TO : All Bidders  
FROM : George M. Wiens  
PROJECT : CTE Classroom Addition  
Vista Murrieta High School  
1615400.41  
SUBJECT : Addendum 2  
DSA : 04-115755 / 33-H18

Addenda No. 2 – Scope of Work Questions

DRAWING NUMBER: **E4.1**

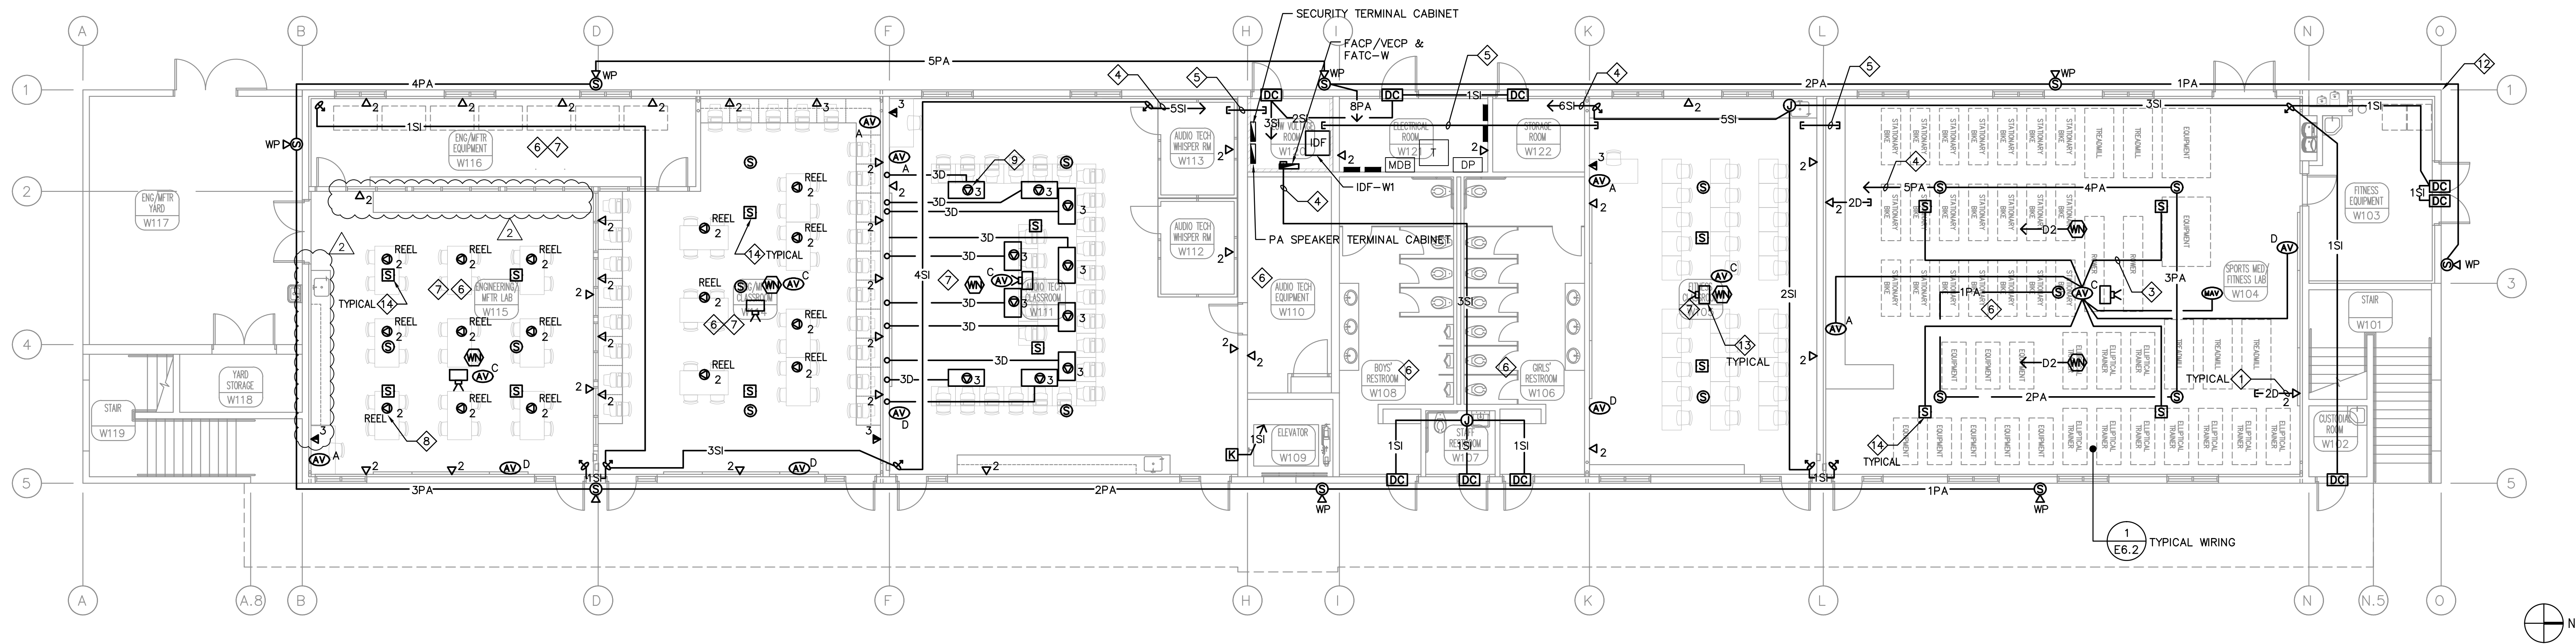
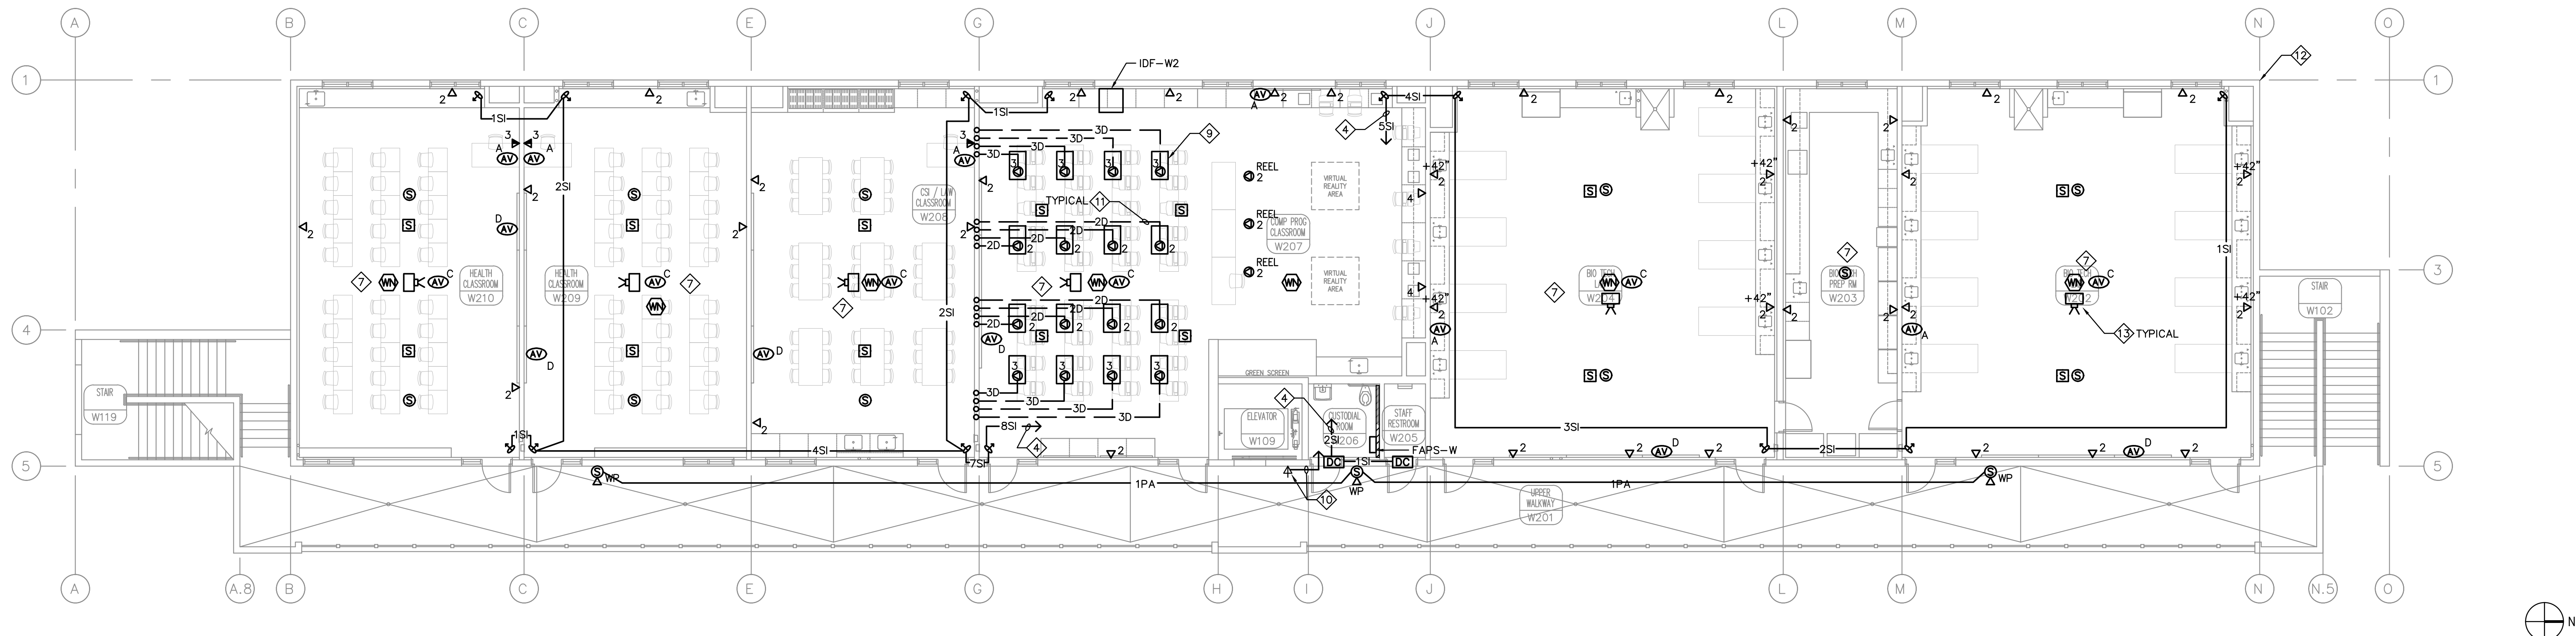
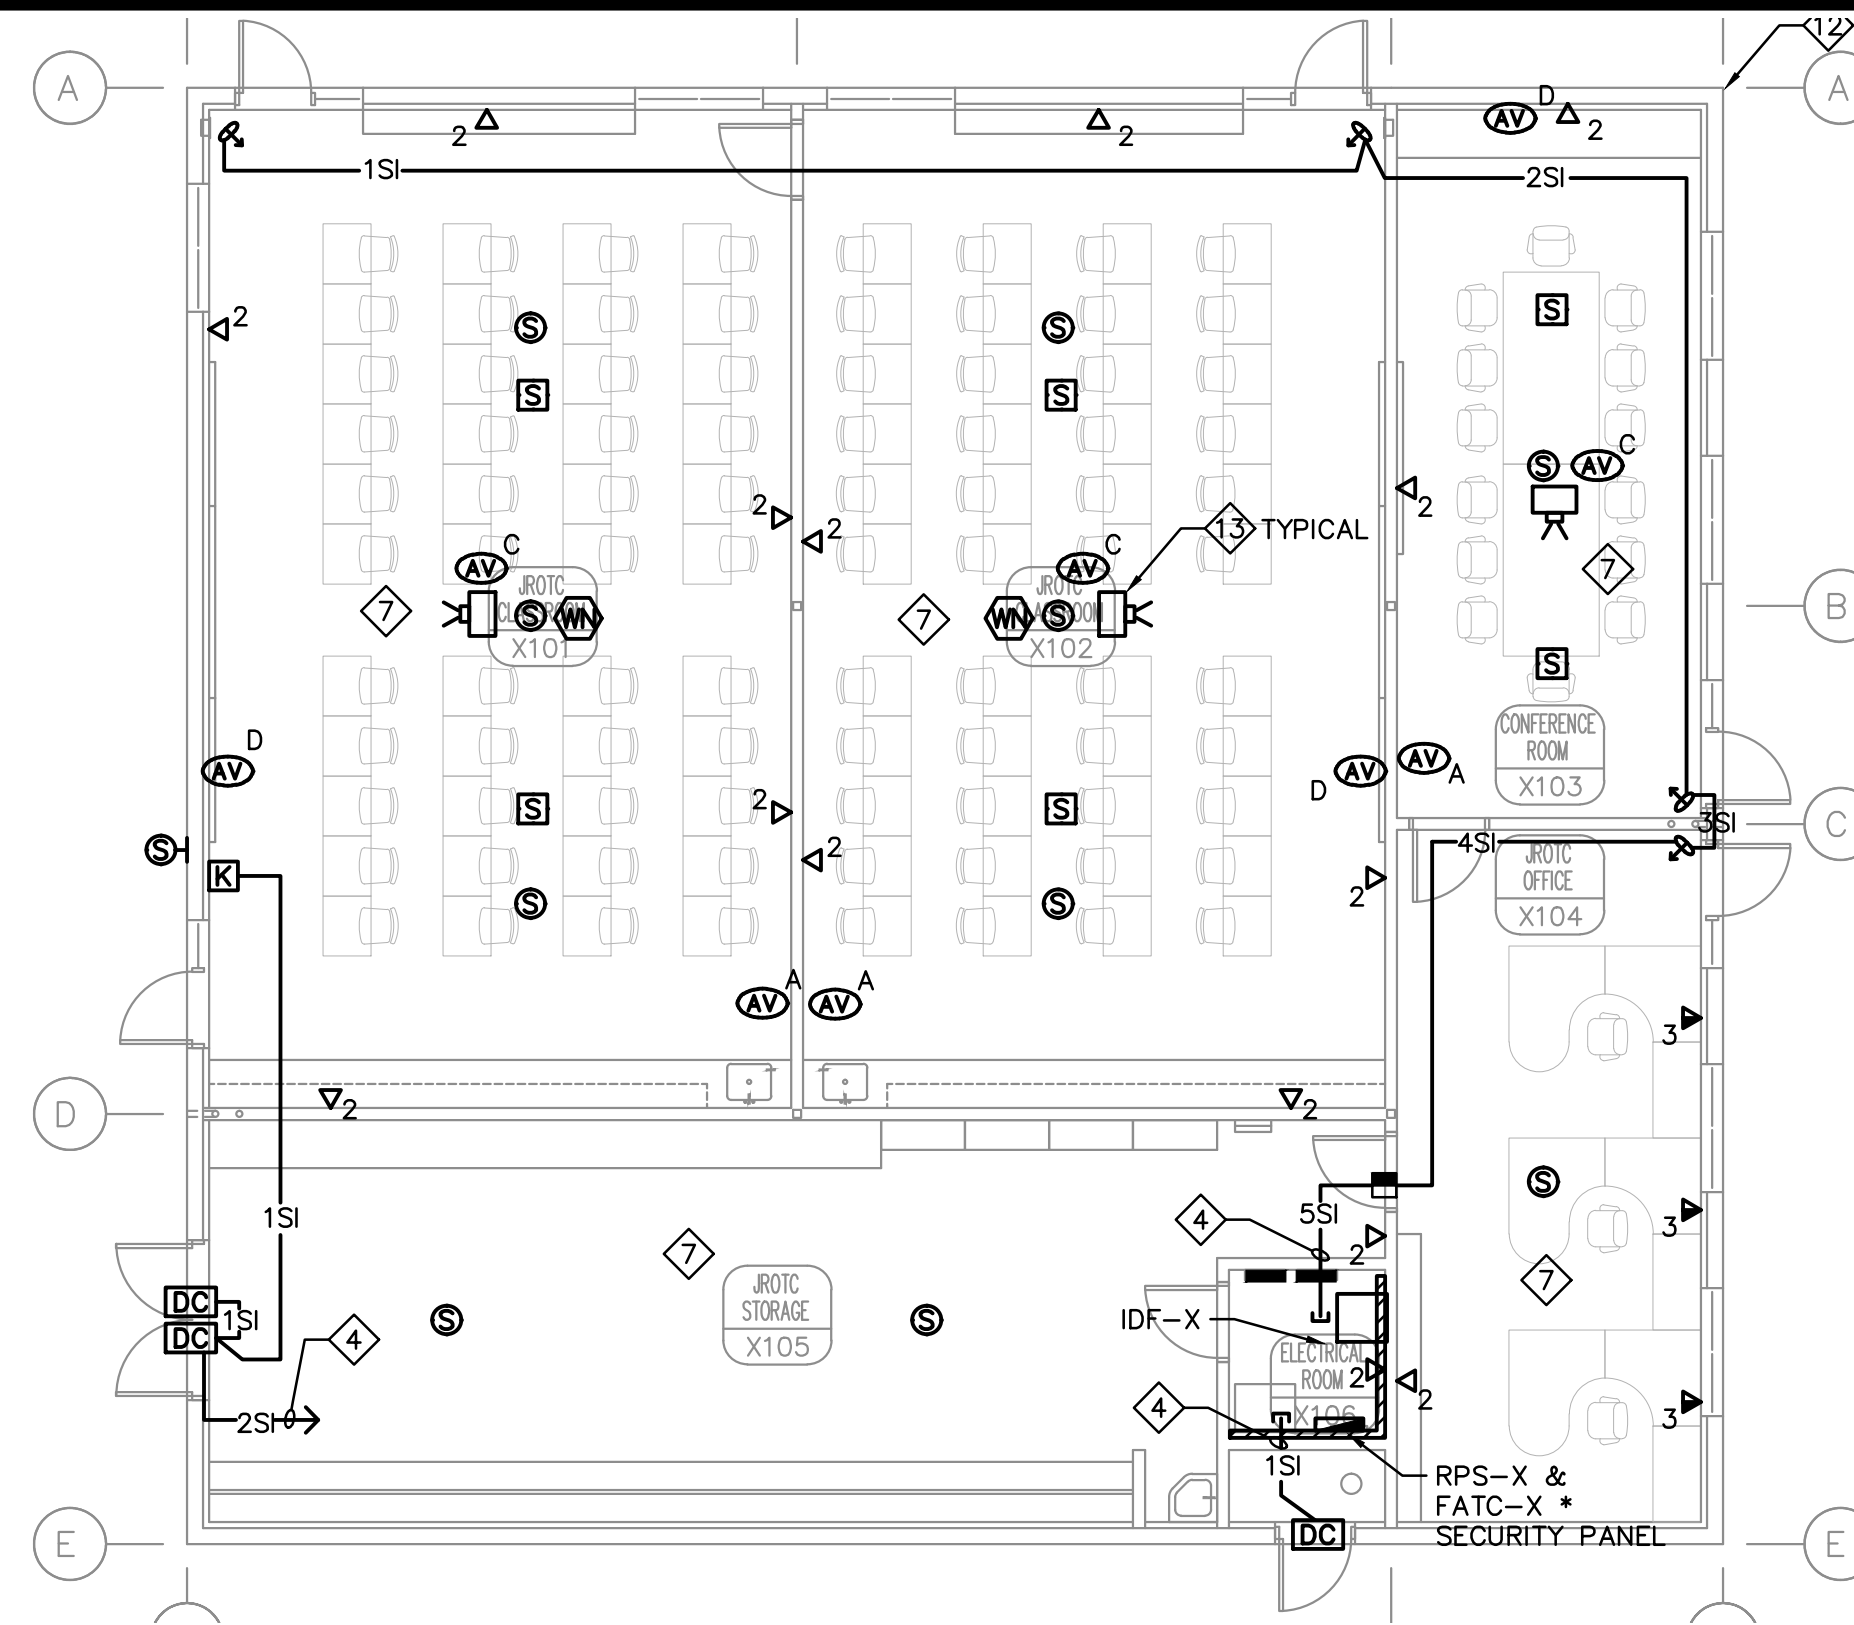
A. Revise as indicated in the clouded area labeled Delta 2 on the attached E4.1.
